Subject: Incidental Take Permit Amendment for Calaveras Dam Replacement

Project, 2081-2019-008-03, Amendment No. 1

AMENDMENT NO. 1

(A Major Amendment)
California Endangered Species Act
Incidental Take Permit No. 2081-2019-008-03
San Francisco Public Utilities Commission
CALAVERAS DAM REPLACEMENT PROJECT
in Alameda County

Construction Phase I – Creek Channel Access Plan

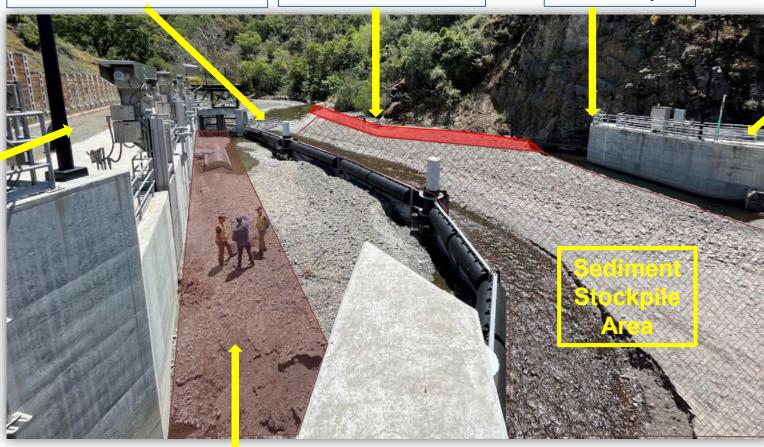
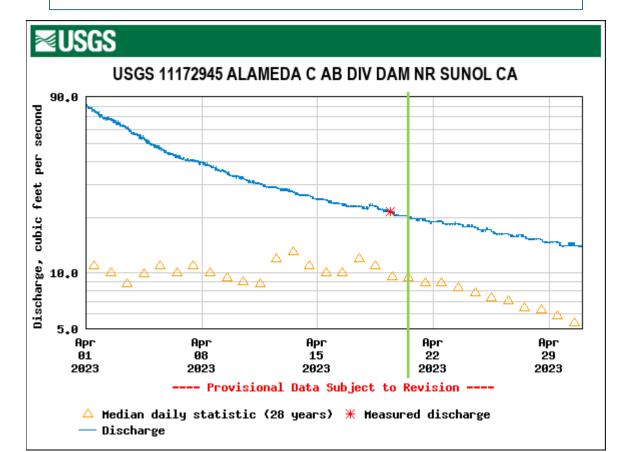
Phase I Screen Rehabilitation Work Locations

One Creek Crossing w/ Excavator

Creek Bypass
Channel Location

Gate V-007 Sluiceway 2

Creek Access Road

ACDT Sediment trap

Screen Sediment Excavation Area

Equipment Crossing Within Wetted Perimeter of Creek

OCTOBER 2022 AND MEDIAN USGS FLOW DATA

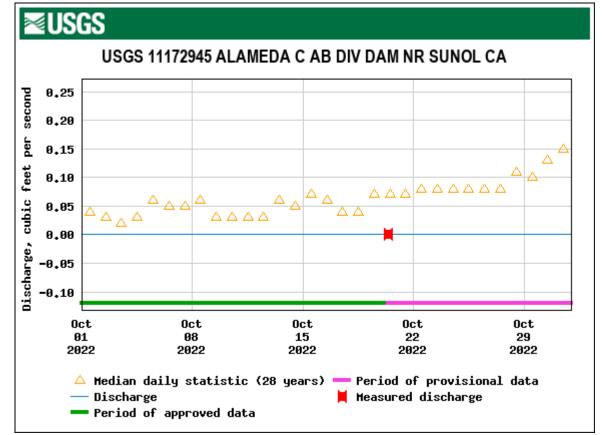
Post Bypass Installation – Flow May Not Be Present

If flow is present during initiation of work, one crossing with a mini excavator is proposed.

Photo provided above was modified to depict Alameda Creek with minimal to no flow present.

Work targeted for October 2023 timeframe. Median daily flows based on past 28 years of USGS data collection is ~0.05 CFS.
